Access Compliance Report Public Rights-of-Way (Curb Ramps)

Main Street: YORBA_ST Cross Street: SANTA_CLARA_AVE Location: NE

ADA ID: RPRK220127120105 Ramp Type: Type 4 - Parallel Initial Pass/Fail: Fail Overall Compliance: No Severity Score: 2

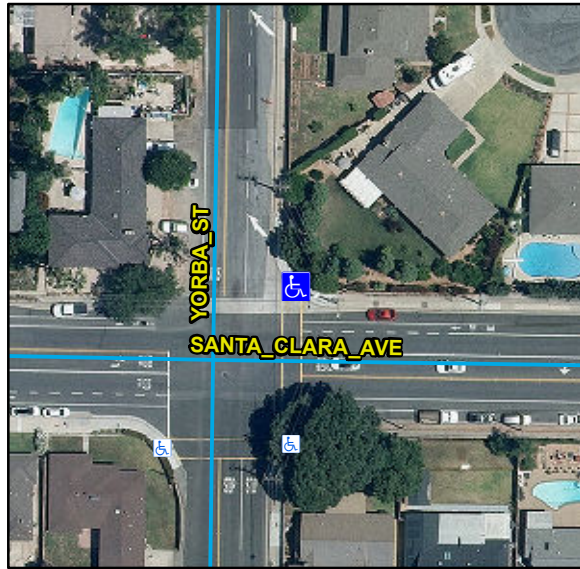
Compliance	Description	Data	Compliance	Description	Data
N/A	Ramp Length LT (in)	116	N/A	Ramp Length RT (in)	82
Yes	Ramp Width LT (in)	83	Yes	Ramp Width RT (in)	83
Yes	Ramp Run Slope LT (%)	6.1	Yes	Ramp Run Slope RT (%)	4.7
Yes	Ramp Cross Slope LT (%)	1.5	No	Ramp Cross Slope RT (%)	2.3
N/A	Landing Present	N/A	N/A	DWS Provided	N/A
N/A	Landing Length (in)	N/A	N/A	DWS Contrast	N/A
N/A	Landing Width (in)	N/A	N/A	DWS Length (in)	N/A
N/A	Landing Run Slope (%)	N/A	N/A	DWS Full Width	N/A
N/A	Landing Cross Slope (%)	N/A		DWS Offset Type	N/A
N/A	Landing Movement Obstructed?	N/A	N/A	DWS Offset Left (in)	N/A
	Landing Movement Type	N/A	N/A	DWS Offset Right (in)	N/A
N/A	Landing Shared	N/A			
N/A	Clear Space	Yes			
N/A	Clear Space To Crosswalk (in)	N/A			
N/A	Marked Crosswalk 1	No	N/A	Marked Crosswalk 2	Yes
	Crossing 1 Direction	W		Crossing 2 Direction	S
	Marked Crosswalk 1 Width (in)	N/A		Marked Crosswalk 2 Width (in)	144

Remove & Replace Curb Ramp With Two New Directional Ramps or Equivalent.

R304.5.3, STD 1115
